SUBJECT: Forwards FSAR changes which address SER Confirmatory Item 25.
 re: LPCII & LPCS valve interlocks. One P&ID drawing also encl.

Re: Nine Mile Point Unit 2
Docket No. 50-410

Enclosed are changes to the Final Safety Analysis Report which address Safety Evaluation Report Confirmatory Item Number 25, Low Pressure Coolant Injection and Lower Pressure Core Spray valve interlocks. Also attached are Piping & Instrumentation Diagrams of the Low Pressure Coolant Injection and Low Pressure Core Spray which will be incorporated into the Final Safety Analysis Report. These changes will be included in FSAR Amendment 23.

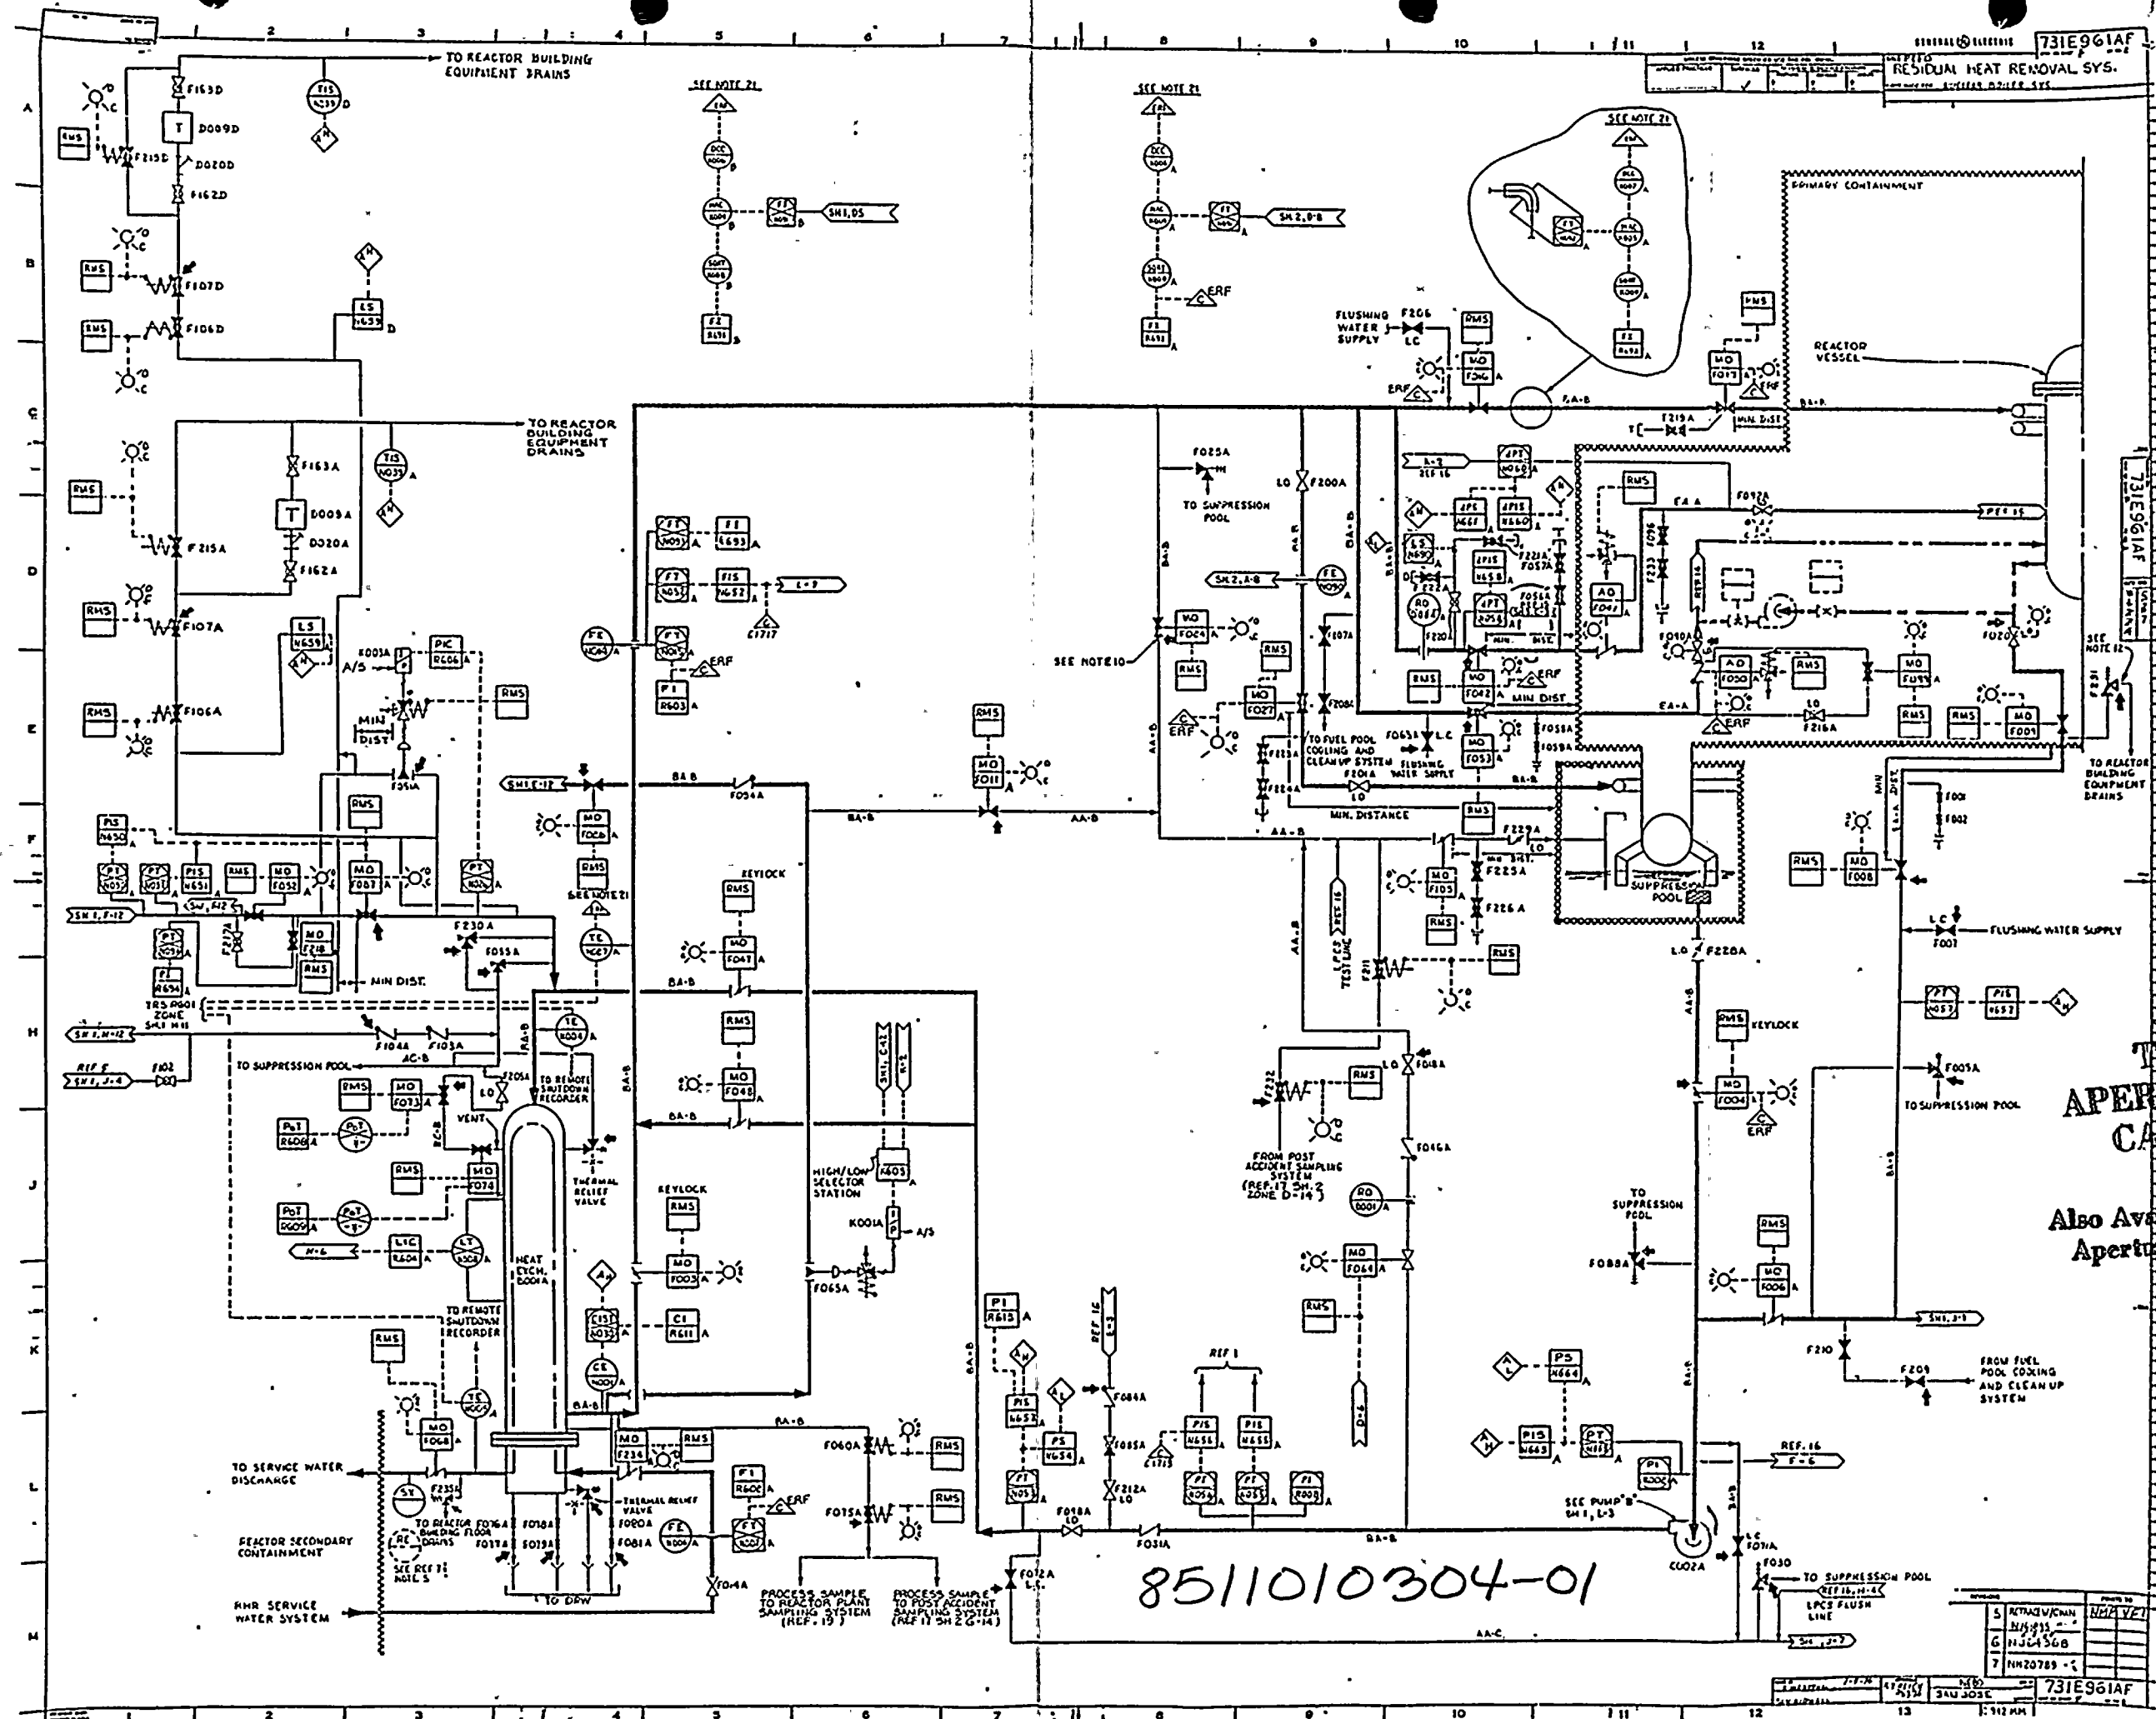
In the RHR head spray line, testable check valves E51-F065 and E51-F066 are in series with MOV E12-F023. Two low pressure permissive signals (two-out-of-two logic) are required for MOV F023 to open. Removal of either signal will close the valve (one-out-of-two logic). Valve position indication for all three valves is provided in the control room.

Because LPCI injection valves E12-F042A, B, and C are part of the emergency core coolant system (ECCS), only a LOCA signal and low differential pressure permissive signal are provided to open valves F042 as is required. Testable check valves E12-F041A, B, and C are downstream of valves F042.

LPCS injection valve E21-F005 is part of the ECCS and includes only a LOCA signal and a low differential pressure permissive signal to open as is required. Testable check valve E21-F006 is downstream of valve F005.

In the RHR steam condensing mode lines, valves E12-F052A and B are in series with valves E12-F087A and B and E12-F051A and B. A LOCA signal will prevent all three valves in each line from opening and will close all three if they were open. Valves F087 have a high pressure interlock that will not allow valves F087 to open and will also close valves F087 on high steam line pressure. Valves F051 are electro-pneumatic converter-controlled air-operated throttle valves. These valves will begin to close at a set heat exchanger shell pressure. The valves will be completely closed before the line's design pressure is exceeded. Operating power to valves F051 are supplied from an essential power source.
